Design Review Responses

Lansdale Pointe Apartments

July 21, 2023

Marked up by Casey Mauck, October 2023

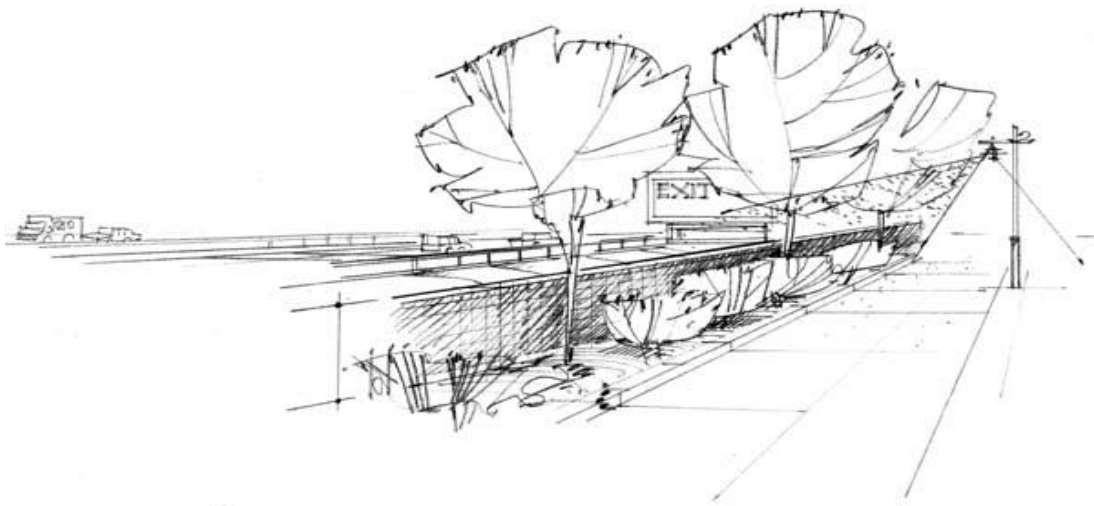
Staff Response: Plans show Big Leaf Maple.

Staff response: Unclear where native vegetation is preserved. Not required.

Response: A 10 ft. wide Type III Landscape Perimeter has been included per the Landscape Plans included in submission. The plan states, "Visual Buffer (Type III) [...] Landscaping shall consist of no more than forty (40) percent deciduous species. [...] Vegetative landscaping shall be a mixture of evergreen and deciduous trees interspersed with large shrubs and ground cover. Tree, shrub, and groundcover spacing shall be appropriate for the species type and consistent with the intent of this section. Additionally, a 6 ft. perimeter fence is proposed surrounding the development, with exception to the property lines fronting public right-of-way. The perimeter fence does include the southern property line along the freeway. Selected perimeter species are native trees and shrubs (~~Western Red Cedar~~, Hemlock and Pacific Wax Myrtle). All are evergreen and appropriately spaced to provide the required screen. Please reference the Landscape Plans.

Response: Native vegetation is preserved elsewhere in the property but is unable to be preserved along the Freeway Corridor. However, the proposed 10' required screen re-establishes an all-native plant screen.

FIGURE 18.170.020

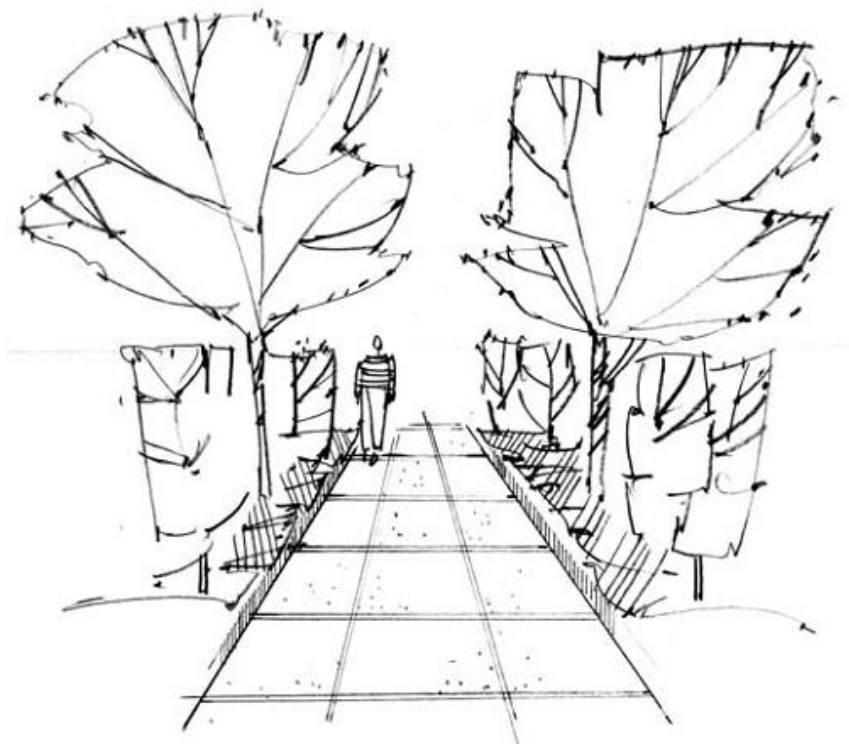
Staff response: Landscaping plan does not appear to distinguish pathways with vertical plantings. Pathways must be distinguished, but not necessarily with plantings.

Response: Pedestrian pathways will be distinguished through use of striping and decoratively scored concrete pavement. Staff response: Plans only show decorative concrete near sport court and playground areas. Pedestrian pathways shown as basic concrete sidewalk. The Board may want to require decorative concrete for pathways.

Staff response: Not included, but probably not appropriate for the site.

Response: Pedestrian pathways are marked with vertical plantings. Refer to the Landscape Plans.

Response: Internal pedestrian connections are provided between project and adjacent properties.

FIGURE 18.170.030-A

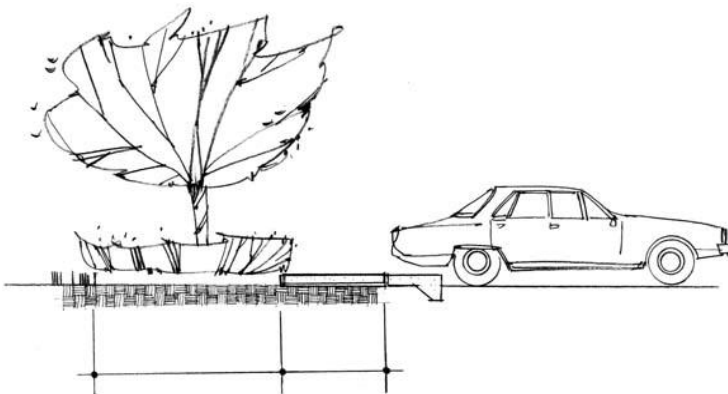
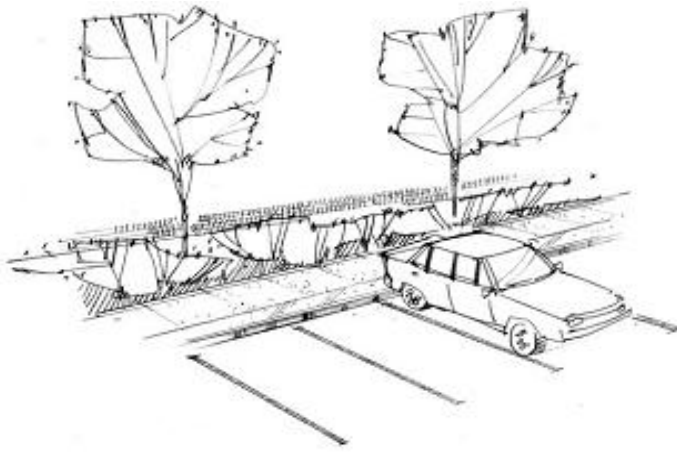
Response: Parking lots on street frontage have been limited to thirty (30) percent or less of the street frontage. **Staff response: Parking is more than 30% of street frontage, however a landscape buffer does screen the parking.**

FIGURE 18.170.050

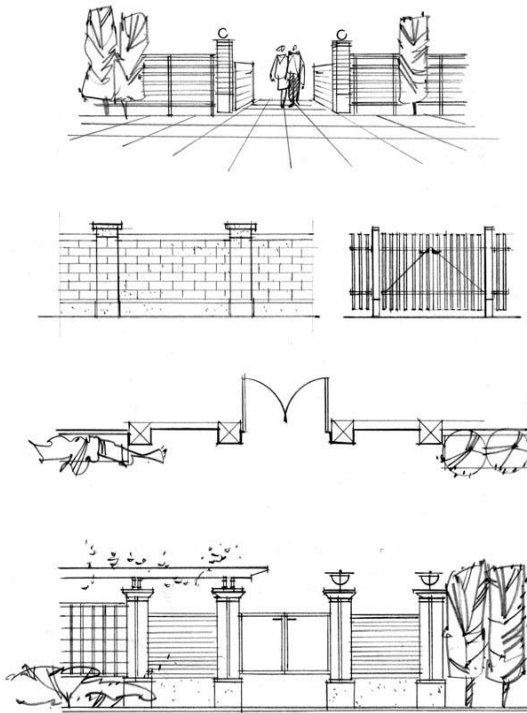
Staff response: Fencing does not have variation, though this is not required.

Staff response: Perimeter landscaping is outside of fence, providing visual interest inside the site only. The Board may want to discuss if external screening is necessary.

Staff response: Perimeter landscaping is outside of fence, providing only internal screening.

Staff response: Scored concrete only surrounds open space buildings; lighting may or may not be considered decorative. Note: pole entry lights on site rendering (sheet 5) do not match fixtures A1-4 shown on lighting plan. The Board may want to discuss if decorative concrete should be used in other places throughout the site, and if light fixtures shown in lighting plan are sufficient to add visual interest.

Response: Perimeter fencing is proposed with exception to property lines abutting public right-of-way. Front yards are visually open to the street.

Response: The perimeter fence is composed of solid board cedar and is 6' high. Visual interest is added via the landscape perimeter, which is a type III visual buffer. This type of landscaping is intended to provide partial visual separation of uses from streets and main arterials and between compatible uses to soften the appearance of structures.

Response: Landscape is proposed that breaks up the appearance of fencing.

Response: Decorative lighting, trellises, and scored concrete have been provided around the entries to building to add visual interest.

FIGURE 18.170.070

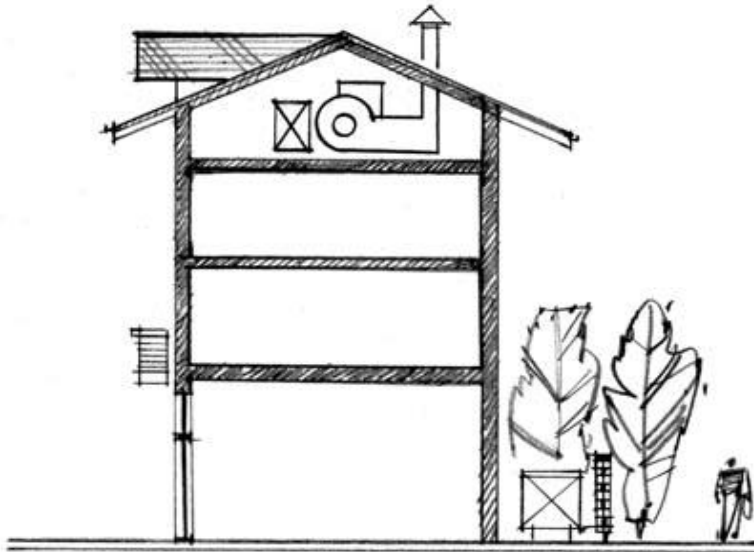
Staff response: It's unclear if this has been achieved. The Board may want to add a condition requiring a landscape screen around any above ground equipment visible from the ROW.

Response: Mechanical equipment utilities will be screened at grade with vertical plants, such as trees, shrubs or ornamental grasses.

FIGURE 18.170.090

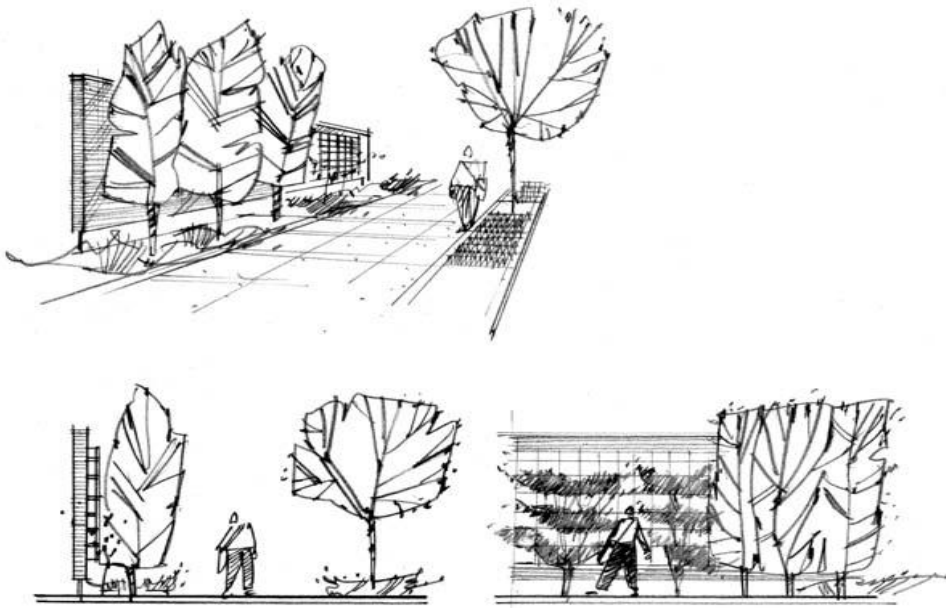
Staff response: Screening interior of site only. Outside site, fence presents a long blank surface. This may not be needed given the character of the surrounding neighborhood.

Response: Fences are screened with vertical landscaping.

FIGURE 18.170.100-A

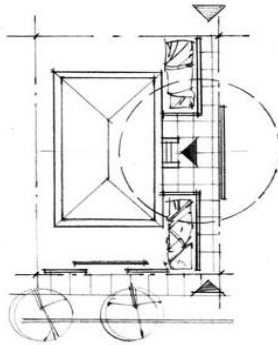
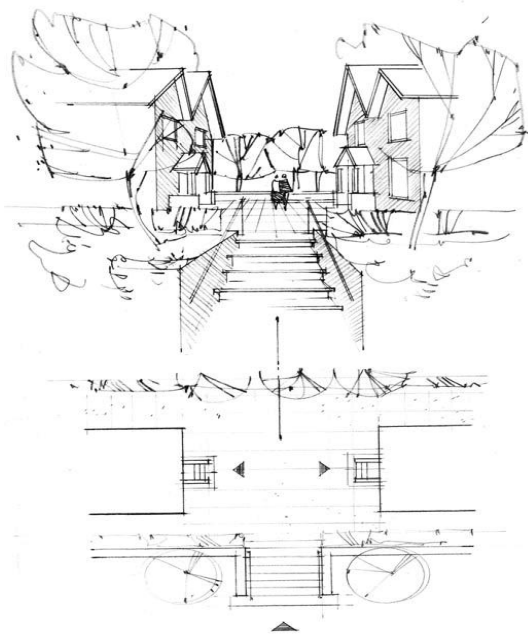
Staff response: Scored concrete only shown at open space buildings. The Board may want to require this in additional areas.

Staff response: Buildings have exterior stairways, but they are located near the middle of the buildings.

Response: We have proposed providing covered entry dormers that have stone at the base of the heavy timber columns. These will happen at each entry that faces a street or entry from the drives/parking within the site. These entry areas will also have decorative scoring patterns in the concrete area incorporating a trellis, bench and decorative light fixture to further enhance the sense of entry to each building.

Response: We have no exterior stairways on these buildings. The stairways are located within the exterior perimeter of the building. They are further screened by the provided entry porch.
